3. CASE 24.040, 225-227 BROADWAY, House, c1870 (BROADWAY)

**Proposal:** The scope of work proposed consists of Major Alterations and includes:

Project: Multi-Family Residence  
Address: 225 Broadway, Providence, RI 02903  
Date: 1 April 2024  
Re: Application Information

## **NARRATIVE – Scope of Work**

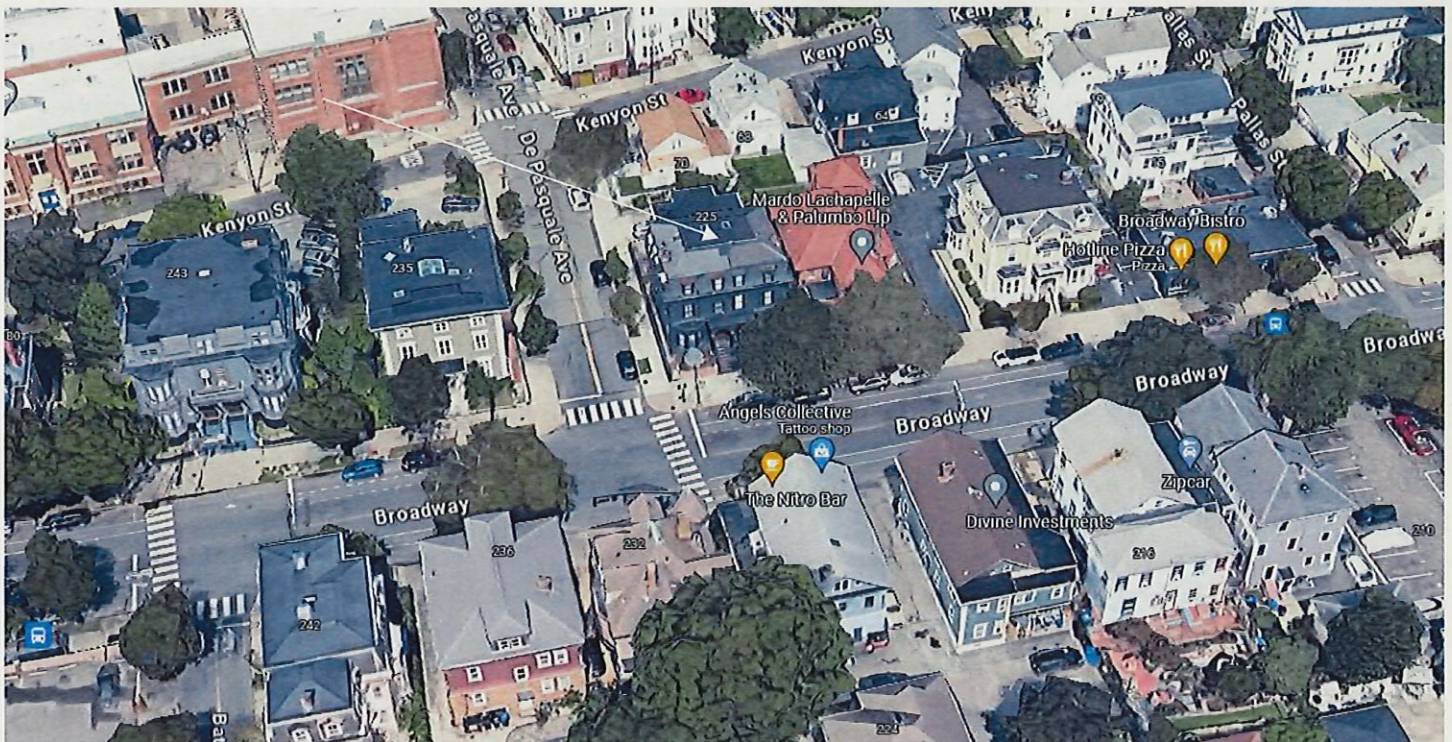
- The new units shall be Marvin "Elevate" insert double hung windows with fiberglass exterior and wood interior. Units fit just behind exterior casing and are made weathertight with sealant and backer rod between the unit and the casing. New window screens to be half-window. Exterior color to be black. The applicant would like to replace the existing sashes with new sashes for three reasons: Energy Efficiency – The new sashes, with insulated glass, and more efficient jamb liners and function are an improvement in air infiltration and U-value over the existing single pane windows with storm windows. The existing storm windows have weep holes in the sill which allow air to enter the building. Also, the weight pockets are to be filled with spray foam insulation to complete the envelope insulation. Aesthetics – The Owner is willing to install replacement windows which are nearly identical to the existing ones. The muntin size and spacing will be matched. The difference in glass area reduction is 6.5% for unit "B". From the exterior, the new sashes, along with removal of the storm windows, will result in windows which are close to the original in size, function, appearance and profile depth with windows within the wall plane, which is diminished by the storm windows. Lead Safety – The removal of the existing painted wood sashes, combined with the new sash operation with greatly reduce lead exposure within the building. It is the applicant's assertion that the replacement units for this building closely match the design intent and function of the existing units. The window frames along with exterior casings and trim are to remain. Improving building performance and safety, while maintaining design integrity is the goal of this work.

- Most units will have a 2/2 configuration with thinner units as 1/1, window sizes shall remain the same
- The existing sashes and aluminum storm windows shall be removed; and,

- The house is a multi-family and is required to obtain a lead-safe certificate for compliance with RIGL § 42-128.1-8; and,
- An architect's narrative, plans and photos have been submitted.

**Recommendations:** The staff recommends the PHDC make the following findings of fact:

- a) 225-227 Broadway is a structure of historical and architectural significance that contribute to the significance of the Broadway local historic district, having been recognized as a contributing structure to the Broadway/Armory National Register Historic District;

- b) The application for Major Alterations is considered complete; and,
- c) The work as proposed is in accord with PHDC Standards 2 & 8 as follows: the proposed alterations are appropriate having determined that the proposed construction will be similar in size and appearance to the existing, matching in visual features (Standard 2) and is architecturally and historically compatible with the property and district having an appropriate size, scale and form that while diminishing the historic quality of the property will not have an adverse effect on the property or district (Standard 8) while allowing the property to come into compliance with RIGL § 42-128.1-8.

**Staff recommends a motion be made stating that:** The application is considered complete. 225-227 Broadway is a structure of historical and architectural significance that contribute to the significance of the Broadway local historic district, having been recognized as a contributing structure to the Broadway/Armory National Register Historic District. The Commission grants Final Approval of the proposal as submitted having determined that the proposed alterations are appropriate as the proposed alterations will be similar in size and appearance to the existing, matching in visual features (Standard 2) and architecturally and historically compatible with the property and district having an appropriate size, scale and form that while diminishing the historic quality of the property will not have an adverse effect on the property or district (Standard 8) and allows the property to come into compliance with RIGL § 42-128.1-8, citing and agreeing to the recommendations in the staff report, with staff to review any additional required details.
